RE: Sunport Cell Phone Parking Lot

2200 Sunport Blvd. SE Grading & Drainage Plans

Re: TR A-1 Plat of TRS A-1 & A-2 Sunport Municipal Addn. (M16D024C) 2200 Sunport Blvd. SE Grading and Drainage Plan

RE: TR A-1 Plat of TRS A-1 & A-2 Sunport Municipal Addn. (M16D024C) 2200 Sunport Blvd. SE **Grading and Drainage Plan Engineers Stamp Date 8/26/2022**

100-YR & 90th PERCENTILE STORM EVENTS HYDROLOGIC CALCULATIONS

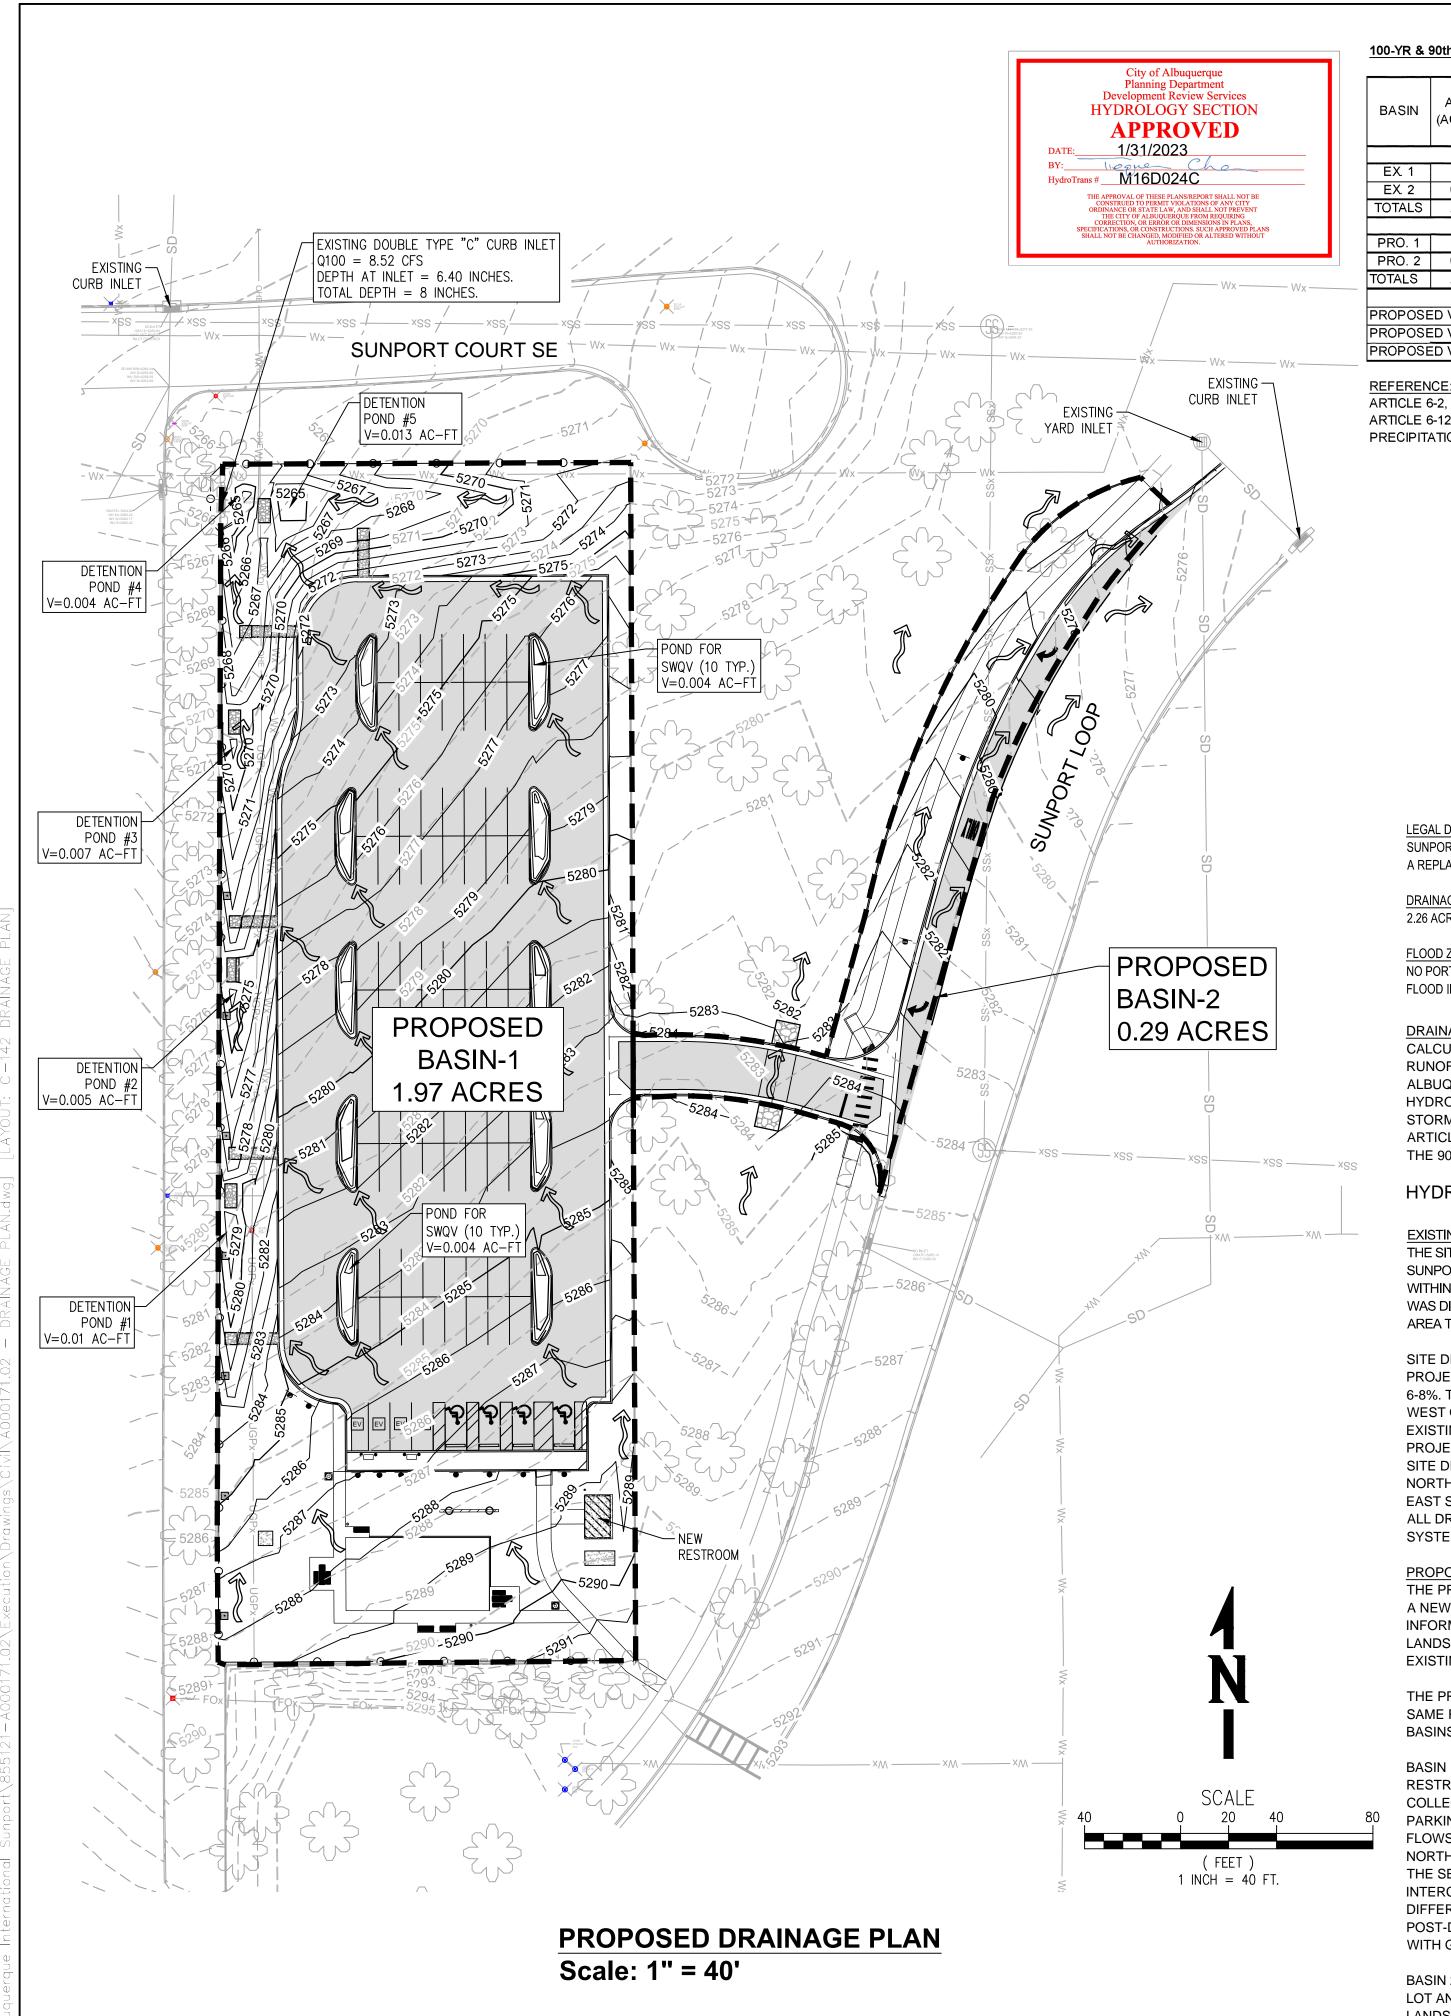
- 6) First Flush Volume (using storm water quality pond/retention pond) must be provided per the DPM. Detention ponds as mentioned on the plan does not address the First Flush Volume requirements.

Not Concur. The first flush volume was computed, see calculation on sheet C-142 Drainage Plan, first flush volume was captured within the proposed detention ponds and landscape islands.

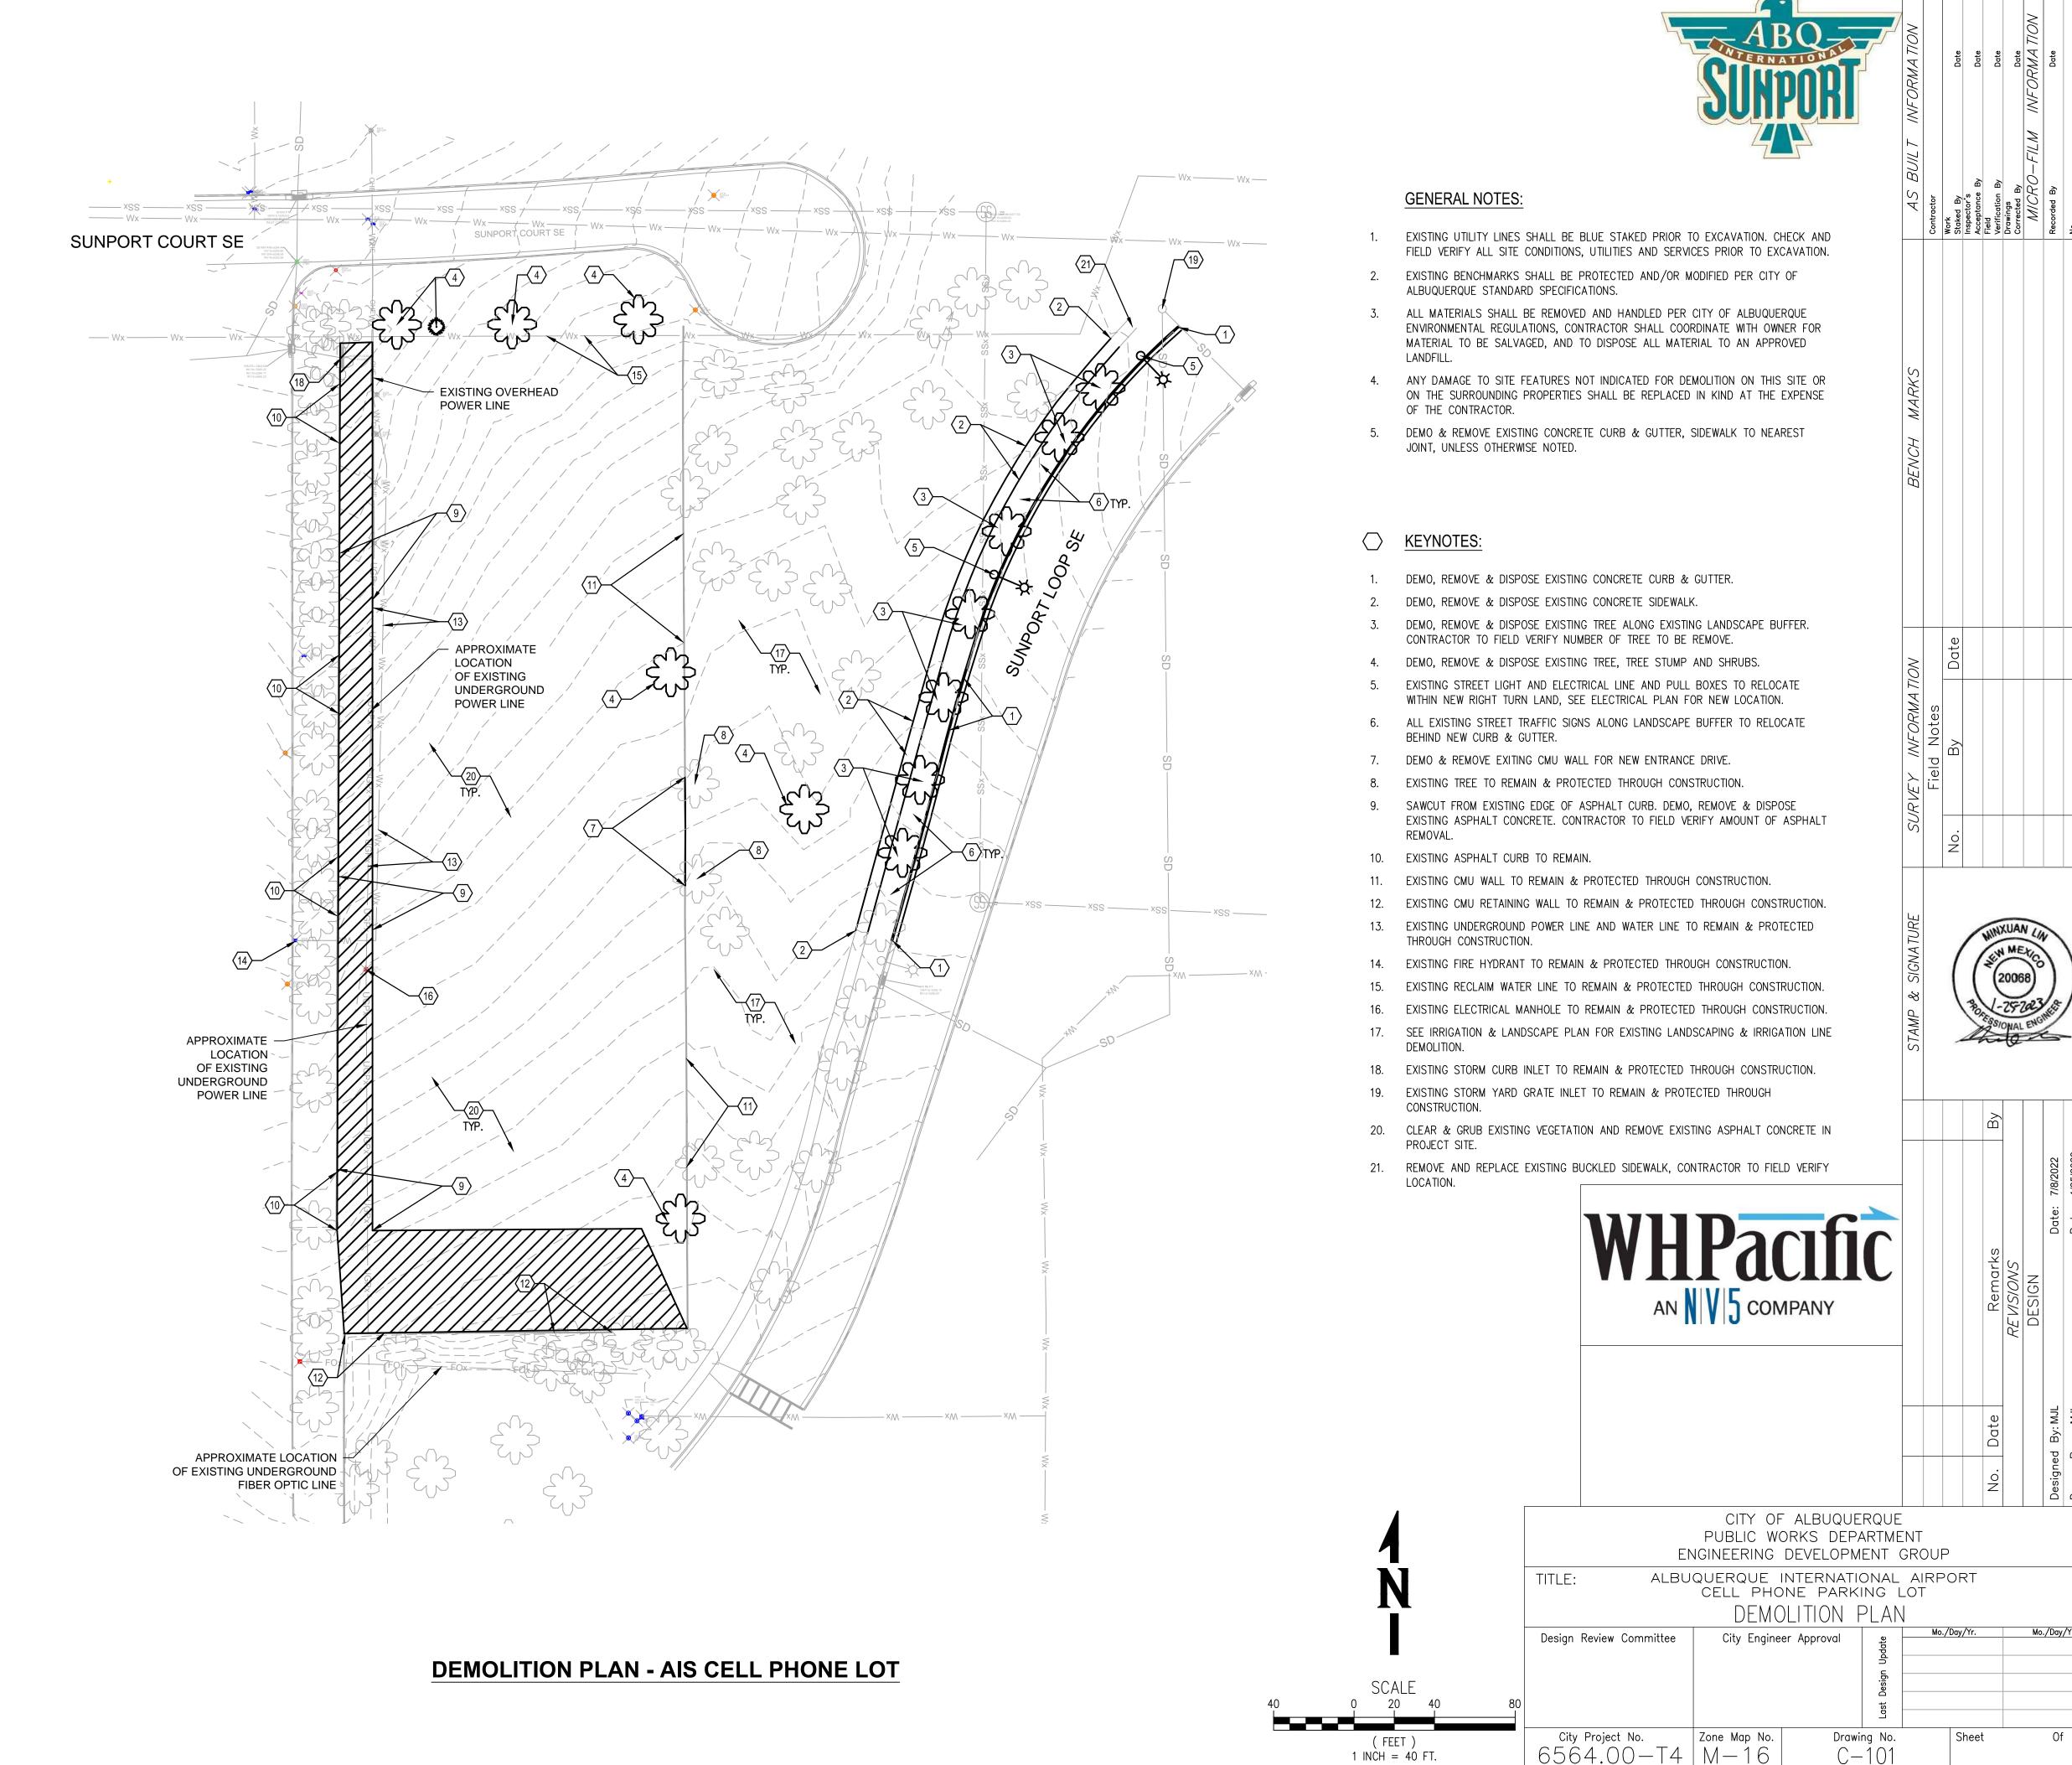
1) How many mature trees will be taken out as part of the deceleration lane and entrance construction. It does not appear that all existing three are shown on the plan. Eight (8) mature trees will be taking out as part of the deceleration lane and entrance. Trees will be replace, see sheet C-101 & LP-101 for demolition plan and landscape planting plan.
